DEVELOPMENT APPLICATION ASSESSMENT REPORT

Application Number:	DA2024/1677
---------------------	-------------

Responsible Officer:	Jordan Howard
Land to be developed (Address):	Lot 2 DP 534838, 7 Cliff Street MANLY NSW 2095
Proposed Development:	Alterations and additions to a semi-detached dwelling
Zoning:	Manly LEP2013 - Land zoned R1 General Residential
Development Permissible:	Yes
Existing Use Rights:	No
Consent Authority:	Northern Beaches Council
Delegation Level:	DDP
Land and Environment Court Action:	No
Applicant:	Katherine Marian Keenan

Figure 1 - Extract from Section AA (Drawing No. A 303) depicting building height.

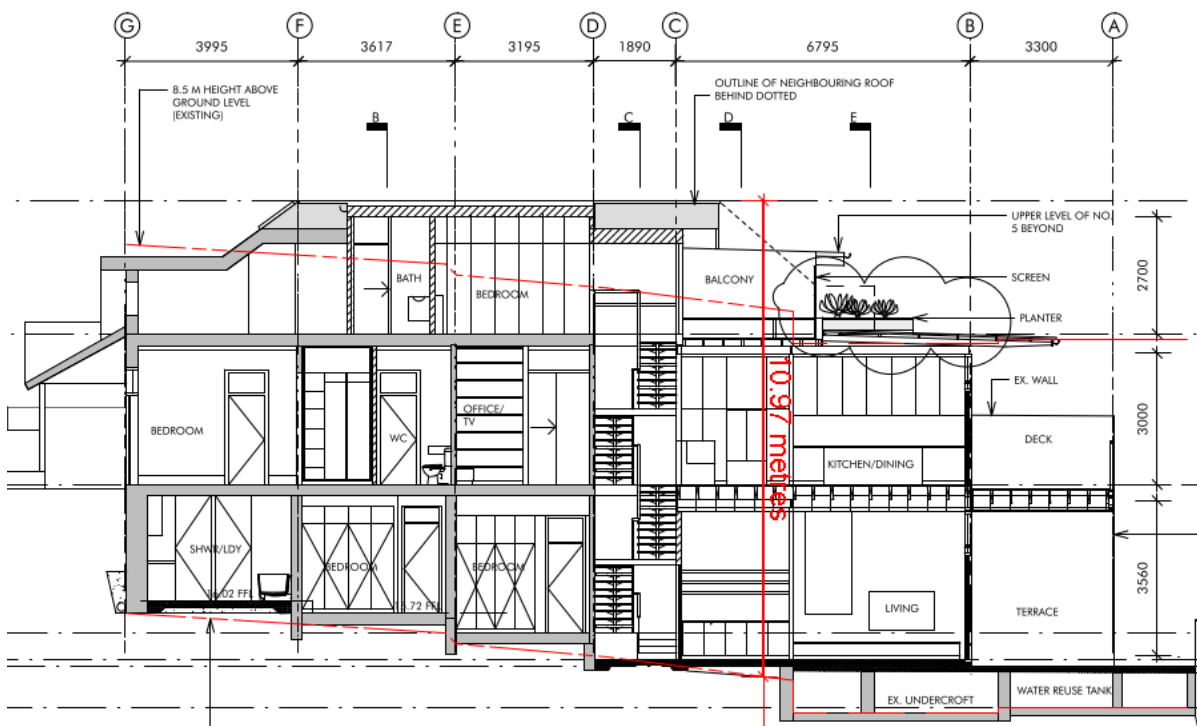
Proposed: 10.97m

Percentage of variation: 29.06%

The arguments provided by the applicant in response to each objective are generally concurred with. The proposed development does not increase the overall ridge height of the existing semi-detached dwelling. Rather the proposal seeks to alter and extend the existing roof form rearward, which due to the sloping site results in an increased height breach. The roof form alterations and additions are largely obscured from the street by being located behind the existing roof. Most importantly, the proposal development will be consistent with the bulk and scale of the adjoining semi-detached dwelling at 5 Cliff Street. The subject dwelling is part of a pair of two semi-detached dwellings with 5 Cliff Street and the proposed alterations and additions generally reflect previously approved and
